Product Change Notice (PCN)

Subject: Addition of back-end production for general-purpose linear IC products (SOP package products)

Publication Date: 6/30/2023

SOP-8 :

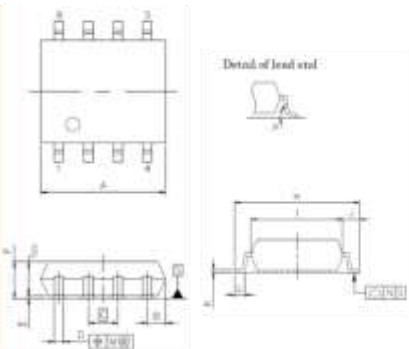
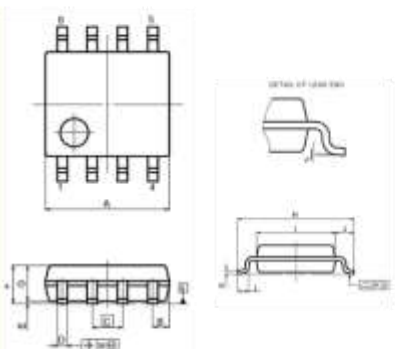
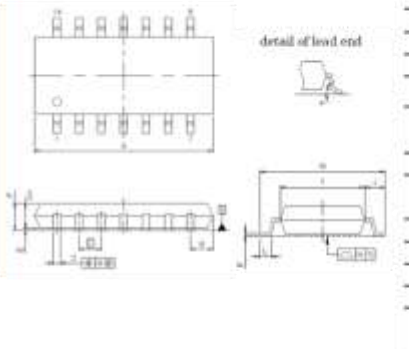
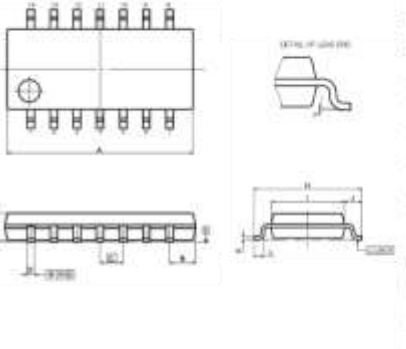
< Form >

There are some dimensional differences in the outline drawing, but the recommended foot pattern remains the same.

(UNIT:mm)		(UNIT:mm)	
ITEM	MILLIMETERS	ITEM	DIMENSIONS
A	5.2 ^{+0.17} _{-0.20}	A	5.2±0.17
B	0.78 MAX	B	0.78MAX
C	1.27 (T.P)	C	1.27(T.P)
D	0.42 ^{+0.08} _{-0.07}	D	0.40±0.05
E	0.1 ±0.1	E	0.1±0.1
F	1.59 ±0.21	F	1.59±0.21
G	1.49	G	1.49
H	6.5 ±0.3	H	6.5±0.3
I	4.4 ±0.15	I	4.4±0.1
J	1.1 ±0.2	J	1.05±0.15
K	0.17 ^{+0.08} _{-0.07}	K	0.2±0.07
L	0.6 ±0.2	L	0.6±0.20
M	0.12	M	0.1MAX
N	0.10	N	0.1MAX
P	3° ^{+7°} _{-3°}	P	4°±4°

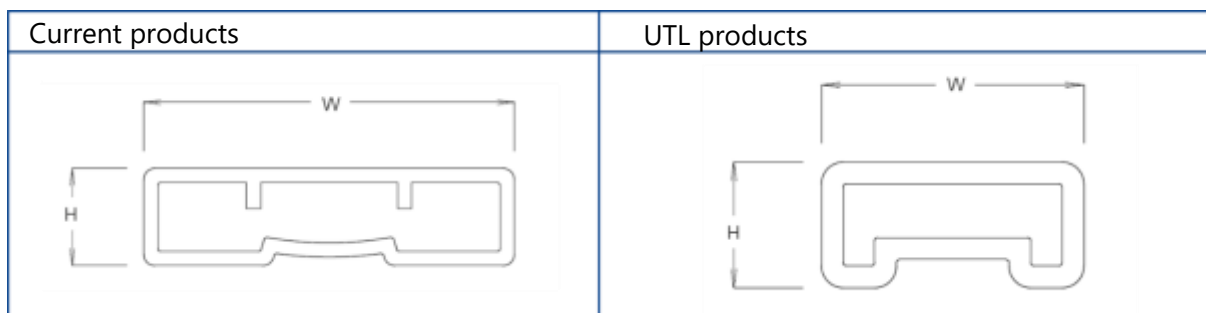
The size of the tape packaging box is different as follows.

This is standard specifications that have been mass-produced.

Current products (L×W×H)	UTL products (L×W×H)
368×347×54 (mm)	355×370×55 (mm)

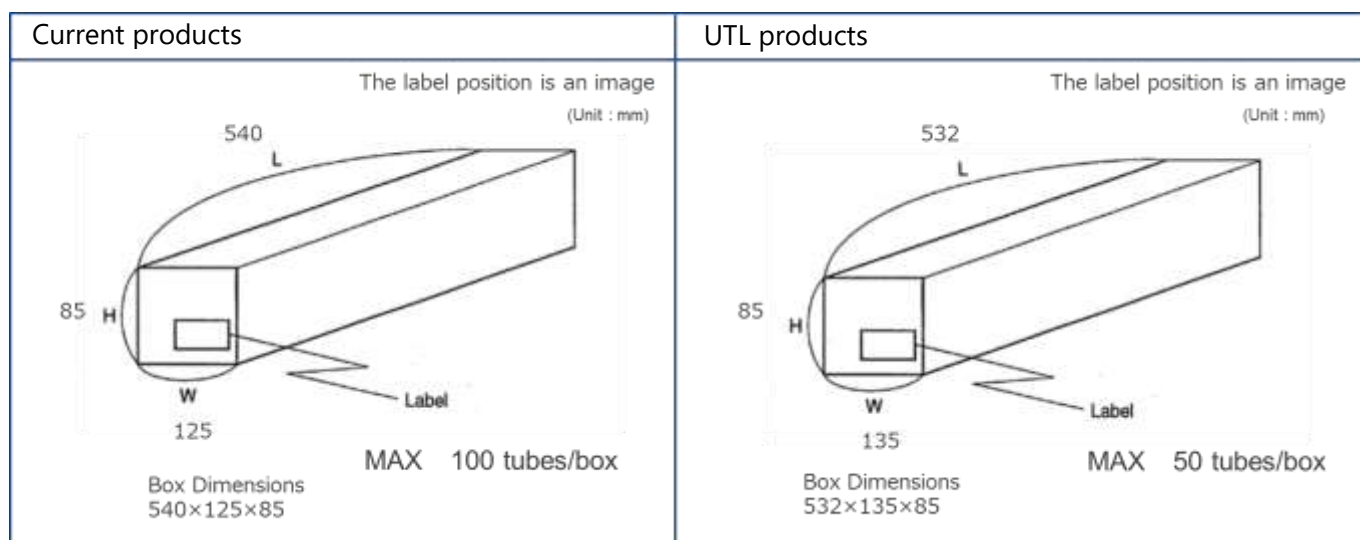
The size of the tube is different as follows.

The tubes are open products and have a track record of mass production.

PKG	Current products (L×W×H), Quantity	UTL products (L×W×H), Quantity
SOP-8	530×13×3.4 (mm), Max100pcs	507~509×8.4×4.0 (mm) , Max90pcs
SOP-14	530×13×3.4 (mm), Max50pcs	507~509×8.4×4.0 (mm) , Max45pcs
